ORDINANCE NO. 5102

AN ORDINANCE APPROVING TML 2-20, A THREE MILE LANE DESIGN REVIEW FOR DRIVE-UP SIGNAGE AT 225 NE NORTON LANE, MCDONALD'S RESTAURANT.

DECISION, CONDITIONS, FINDINGS OF FACT AND CONCLUSIONARY FINDINGS FOR THE APPROVAL OF THREE MILE LANE DEVELOPMENT REVIEW FOR THE ADDITION OF A SECOND DRIVE-THRU SERVICE LANE AND ASSOCIATED SIGNAGE AT 225 NE NORTON LANE.

- DOCKET:** TML 2-20 (Three Mile Lane Development Review)
- REQUEST:** Application for Three Mile Lane Development Review to allow for the construction of a second drive-through service lane and associated signage at a McDonald's restaurant within the Three Mile Lane Planned Development Overlay District.

Figure 3: Applicant's Proposed Site Plan

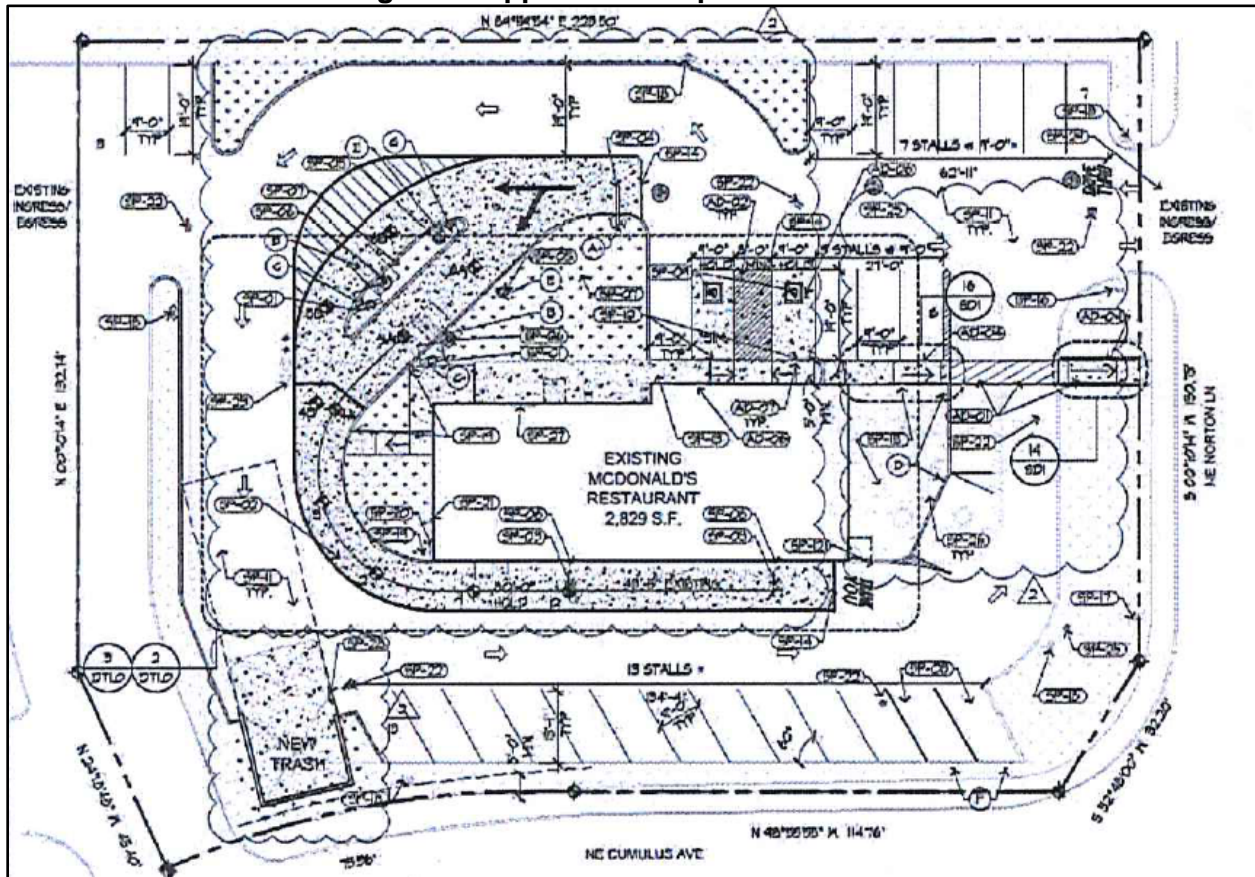
The proposed site design efficiently incorporates the two drive-up service lanes into the existing driveway and parking aisles. To accommodate this, surplus parking was removed, additional landscape area was included, and the trash and recycling enclosure was relocated. Parking requirements and trash enclosure standards continue to be met as described in findings for those sections of the McMinnville Zoning Ordinance described above.

Proposed Gateway Sign

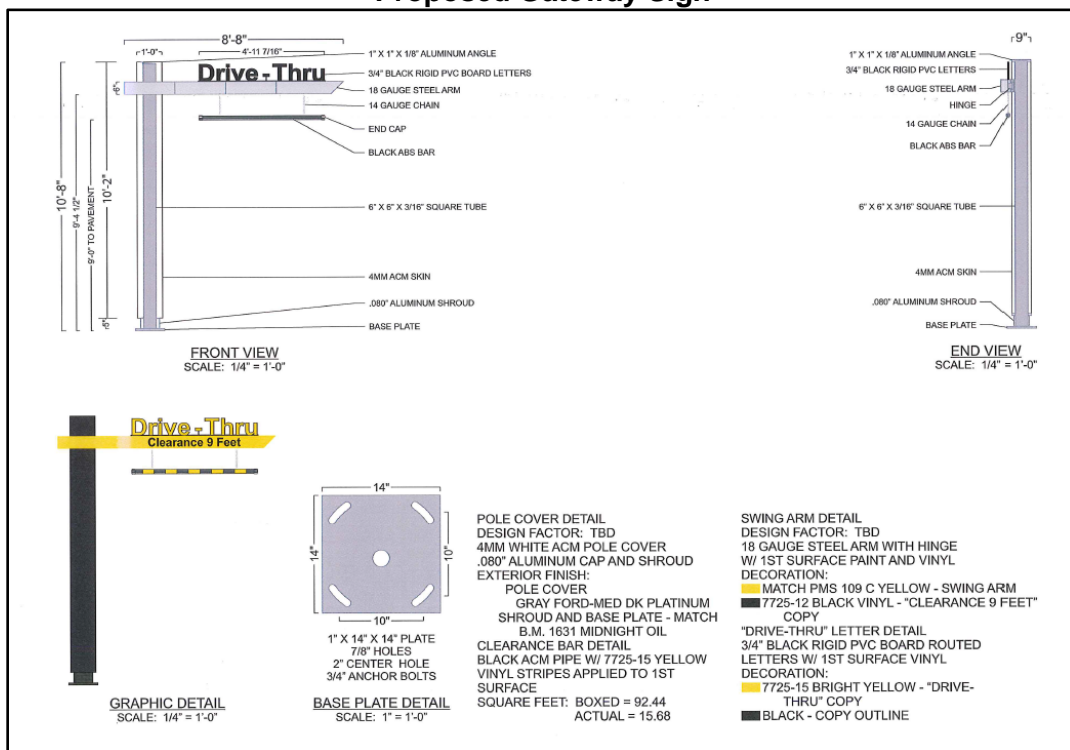
The "Welcome" Gateway Sign, "Any Lane, Any Time" Directional Sign, and each "Order Here" Customer Order Canopies are considered incidental directional signs and are exempt per subsection (B)(3).

Proposed Digital Pre-Browse Board

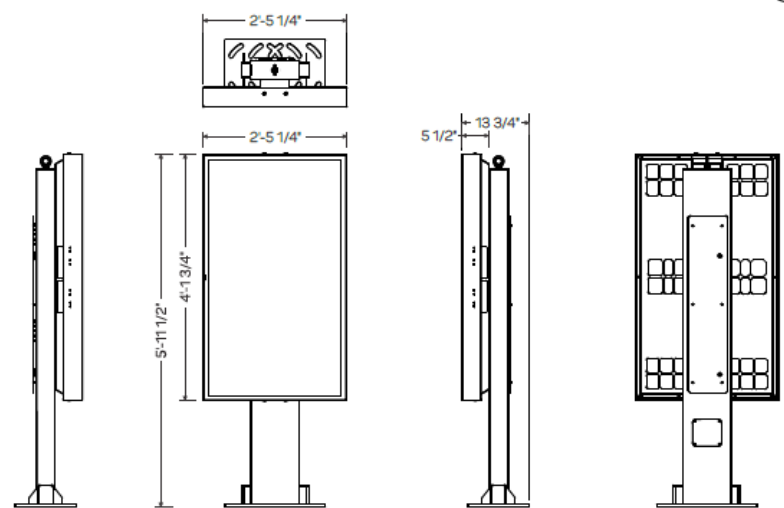
The proposed Digital Pre-Browse Boards are approximately six (6) feet in height with surface areas of approximately 10 square feet. While the area of the Pre-Browse Boards is below the maximum allowed, the proposed height of approximately six (6) feet exceeds the maximum height of five (5) feet for secondary signs allowed per order station. Therefore, a condition of approval is included to require that the Digital Pre-Browse Boards be a maximum of five (5) feet in height. One (1) sign meeting these standards is permitted for each drive-up order station.

That the two (2) Digital Pre-Browse Boards shall not exceed five (5) feet in height.

Proposed Digital Menu Board

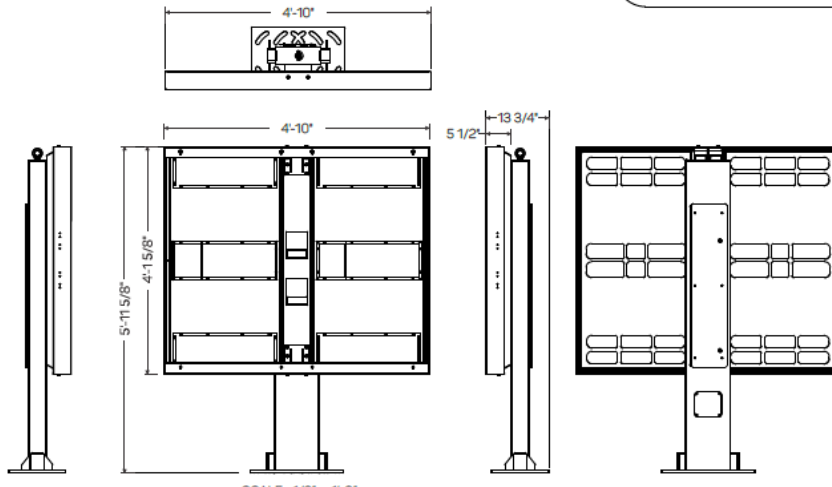
The proposed 1. Digital Menu Boards are less than six (6) feet in height with surface areas of approximately 20 square feet. These dimensions are less than the maximum height and area dimensions for the first additional freestanding sign allowed per order station. One (1) sign meeting these standards is permitted for each drive-up order station.
